**Re: Shell Chemical Appalachia LLC
Shell Polymers Monaca
Application for Plan Approval 04-00740D - WWTP Permanent Controls Project, EMACT
Project, and Plan Approval Reconciliations
PSD Air Quality Analyses and Inhalation Risk Assessment Response to Technical Review
Comments**

Air Dispersion Modeling and Class II Visibility Analysis for Shell Polymers Monaca in Beaver County Pennsylvania

Figure 1. NOx CEMS Data from Cogens 1, 2, and 3 from 2023 and 2024

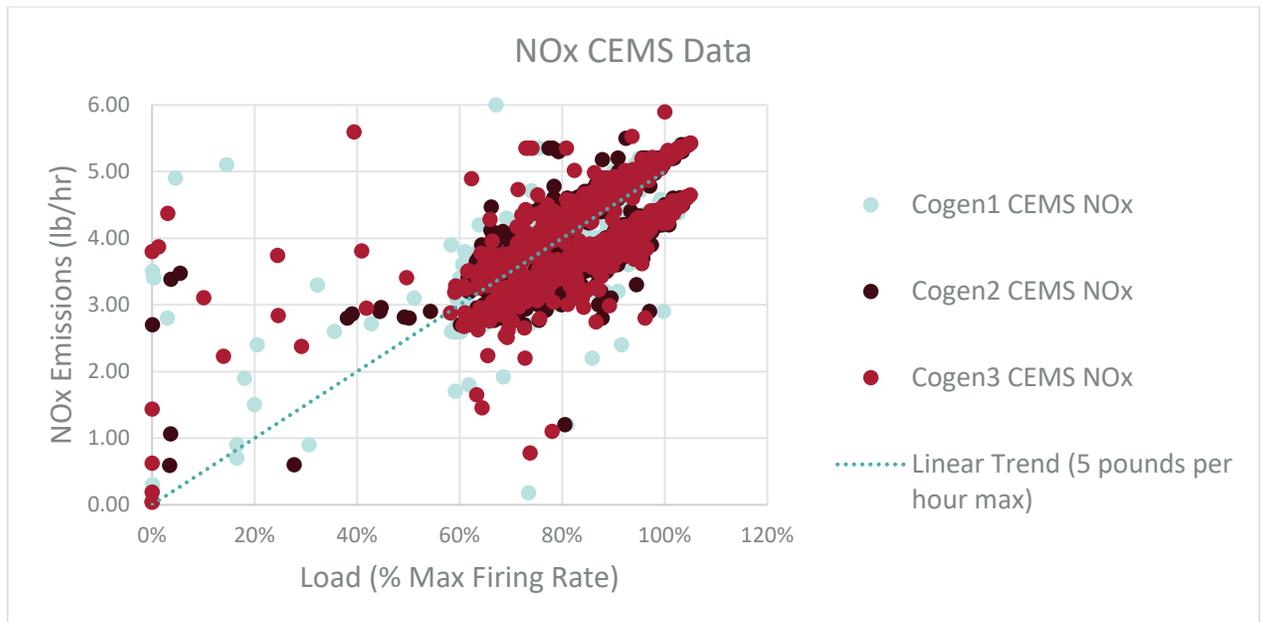
15. The three combustion turbines are equipped with CEMS to measure CO and NOx. Using CEMS data and other required/available monitoring (e.g., load operating level), please confirm and/or demonstrate that the assumption that emissions are “approximately linear with load” is true. Note that under Plan Approval 04-00740A, the combustion turbines are subject to a different CO emission limit during startup and shutdown periods, which are both defined in the plan approval in terms of baseload operating level – i.e., startup begins when the combustion turbine reaches 55% of its baseload operating level while shutdown begins when the combustion turbine drops below 55% of its base load operating level. Thus, it is assumed that for compliance purposes, operating levels of the combustion turbines are being monitored and recorded.

Response: As shown in Figure 1 below, the three combustion turbines 2023 and 2024 CEMS data indicates that the actual lb/hr emission rates for NOx are linear between the 75 percent load and 100 percent load consistent with the load analysis modeled emission rates. Additionally, as shown Figure 2 below, 2023 and 2024 CEMS data indicate that the CO emissions at 75 percent load and 100 percent load are essentially equivalent and do not increase with load as initially anticipated. Finally, as shown in Figures 1 and 2, the combustion turbines rarely run in startup or shutdown mode (i.e., 45 percent load) and are only permitted to operate for 7 hours per year, thus limited data is available at the 45% load rate.

Figure 3. Outlet Flowrate Data from Cogens 1, 2, and 3 from 2023 and 2024

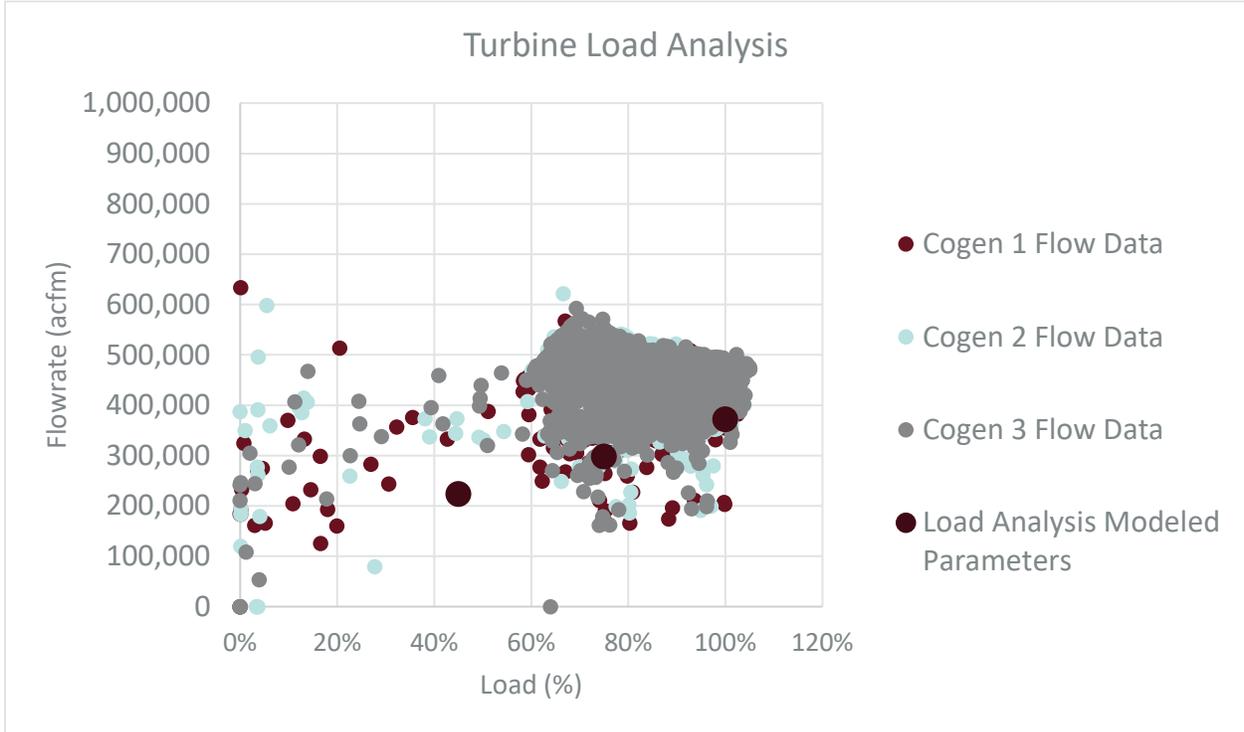
16. In Shell's quarterly CEMS report (e.g., Year 2022, Quarter 3), CO and NOx emissions are reported in terms of 'ppm' and 'lbs/hr'. Having emissions being reported in terms of 'lbs/hr' would indicate that stack volumetric flow rate is being monitored. If the flow/velocity values for the other load conditions (45%, 75%) in the turbine load analysis were not based on measured values, please confirm and/or demonstrate that the scaling applied for flow/velocity at the other load conditions would agree with the trend/relationship based on measurements. As stated in Comment #15, it is assumed that operating levels of the combustion turbines are being monitored and recorded.

Response: Actual flow/velocity for the three combustion turbines is not directly measured but is calculated using F-Factor consistent with Method 19 as allowed under 40 CFR 60 NSPS KKKK. As shown in Figure 3 below the estimated actual flow rates for 2023 and 2024 between the 75 percent load and 100 percent load are equivalent across the two loads. It should be noted that the actual flow rates are approximately 30% greater at 75% load and approximately 12% greater at the 100% load than the modeled flow rates. Because the actual flow rates are higher than those used in the load analysis and the fact that emissions of CO are essentially equal at the two 75% and 100% loads, the previous combustion turbine load analysis is considered conservative and over-predicts impacts of the combustion turbines at the different operating rates. Thus, Shell proposes to retain the current load analysis.

Figure 5. Transport Truck On-site Roadway

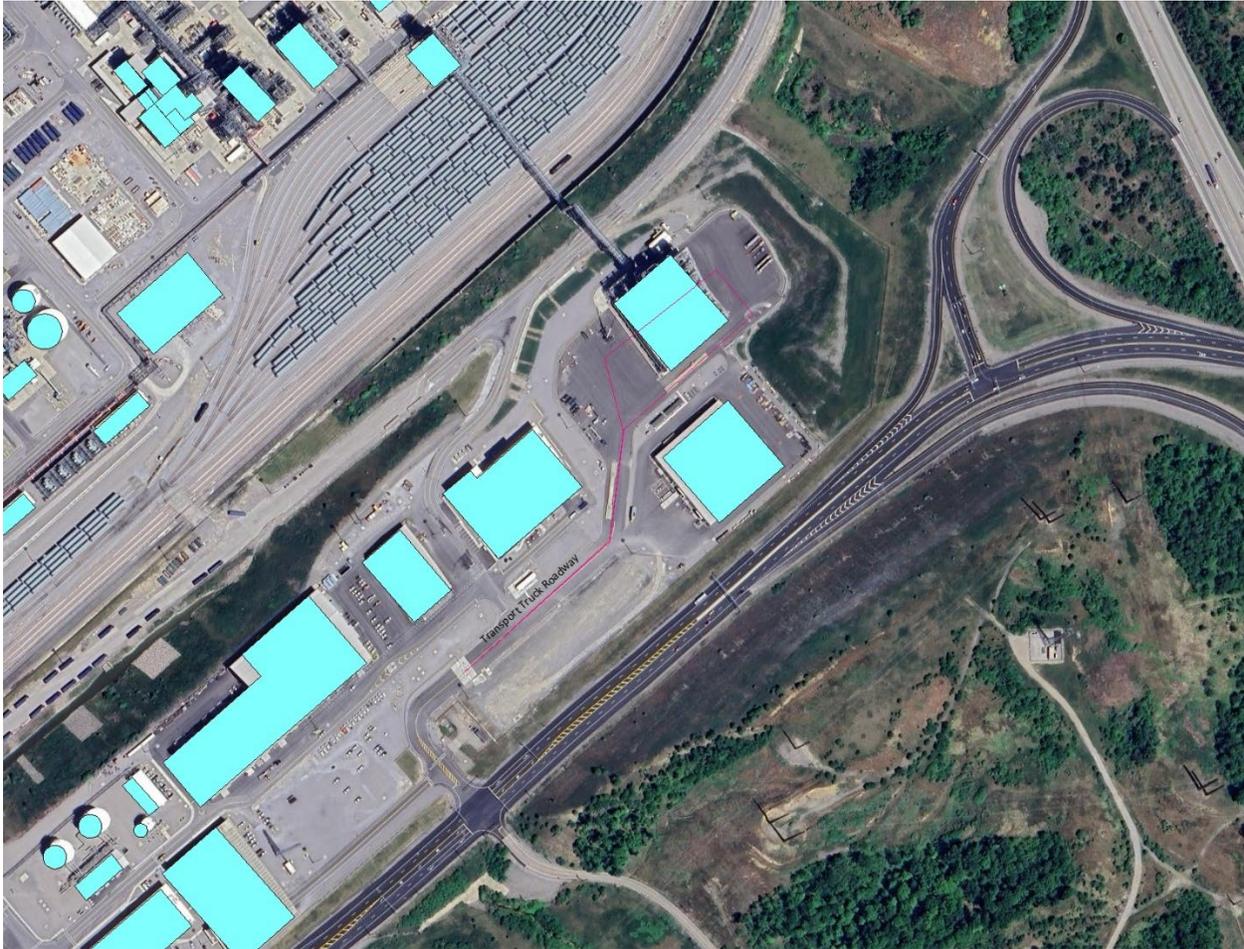
33. On Page A-5, for the table with heading 'Truck Roadway Volume Source Parameter Calculation', 5 steps were shown for calculation of volume source parameters used in modeling emissions from truck roadway. However, as described in the modeling report, under 4.3 Source and Monitoring Data, Volume Sources (and also in the approved June 6, 2024, modeling protocol for the EMACT Project), there are 6 steps in the calculation. Missing in the table on Page A-5 was the calculation of the number of volume sources to be modeled. Please provide the calculation of the number of volume sources representing the truck roadway.

In addition, please confirm and/or clarify the deviation from the documented procedure in calculating the number of volume sources. The September 22, 2020, review memo for Plan Approval 04-00740C documented that the road length was updated from 0.967 mile to 0.49 mile (2,587 feet). Following the steps described under 4.3 Source and Monitoring Data, Volume Sources, there should be 57 or 58 volume sources representing the roadways. However, based on the table on Pages A-3 to A-4, there were 39 volume sources modeled representing the roadways, i.e., 26 for 'Plant Roadways (Transport Trucks)', 13 for 'Plant Roadways (Talc Transport via Trucks)'. These were also the number of volume sources representing the roadways in the 2020 revised PSD modeling.

Response: Shell is proposing to update the emissions from the haul roads to match actual operations on-site. Specifically, Shell is proposing the following changes. See below Figure 4 and 5.

- The pellet transport truck road length used in the PTE is 1.02 miles (5,386 feet). The on-site pellet transport truck road length is 0.49 miles (2,587 feet). The number of volume sources associated with the transport truck traffic is 47.
